Item Name: Fwd Crosstube - Mid Height 206L / L1 / L3 / L4, Blue

DART AEROSPACE LTD HAWKESBURY, ONTARIO, CANADA	
DRAWING NO. D206-667-147	REV. A SHEET 1 OF 4
TITLE CROSSTUBE ASS'Y (206L MID FWD)	SCALE NTS

DRAWING NO. D206-667-147	TITLE CROSSTUBE ASS'Y (206L MID FWD)	REV. A	DART AEROSPACE LTD ENGINEERING ORDER		D.E.O. NO. D206-667-147-A-1	SHEET NO. SHEET 1 OF 1	SCALE NTS
DRAWN 92	CHECKED ASS	MFG. APPR. [Signature]	APPROVED [Signature]		DE APPR. [Signature]		
DATE 11.07.15	DATE 11.07.20	DATE 11.07.21	DATE 11/07/21		DATE 11.07.21

DRAWING NO. D206-667-147	TITLE CROSSTUBE ASS'Y (206L MID FWD)	REV. A	DART AEROSPACE LTD ENGINEERING ORDER	D.E.O. NO. D206-667-147-A-2	SHEET NO. SHEET 1 OF 1	SCALE NTS
DRAWN AJS	CHECKED	MFG. APPR.	APPROVED	DE APPR.		
DATE 12.08.02	DATE 12.08.02	DATE 12.08.02	DATE 12.08.02	DATE 12.08.02	DATE 12.08.02

DETAIL P
BONDING STRAP INSTALLATION 2 PL

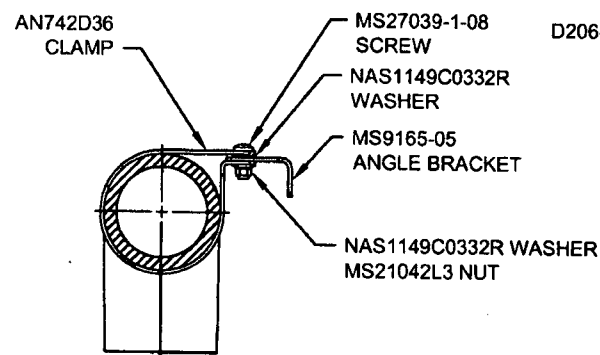
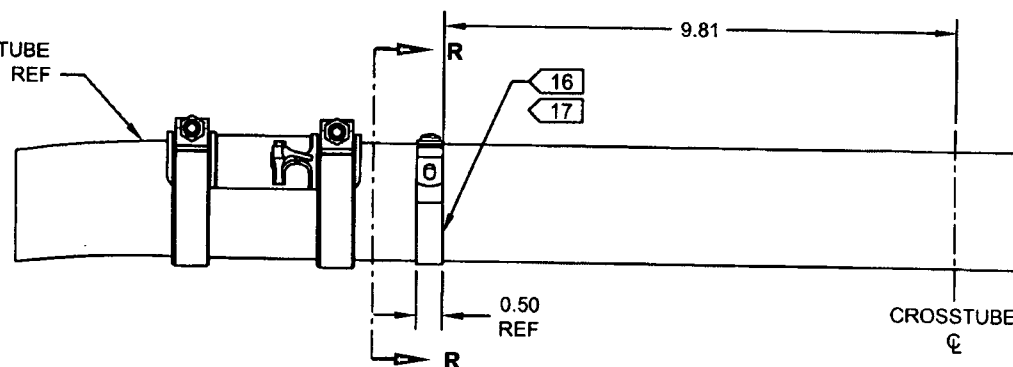
ADD ELECTRICAL GROUNDING STRAP

ITEM	QTY -147	PART NUMBER	DESCRIPTION	
1	X	D206-667-147	CROSSTUBE ASSEMBLY (206L MID FWD)	
10	2	AN742D36	CLAMP	} ADD
11	2	MS9165-05	ANGLE BRACKET	
12	2	MS21042L3	NUT (OR MS21042-3)	
13	2	MS27039-1-08	SCREW	
14	4	NAS1149C0332R	WASHER (OR AN960C10L)

- 16) MASK AREA UNDER CLAMP PRIOR TO PAINTING
 - 17) SEAL EDGES WHERE AN742D36 CLAMP MEETS WITH THE CROSSTUBE USING SIKAFLEX-241/-291 OR MIL-S-8802 CLASS B2 OR PROSEAL 890 SEALANT
 - 18) PERFORM RESISTANCE CHECK TO ENSURE MAX RESISTANCE IS 10 MILLIOHMS
- AFT
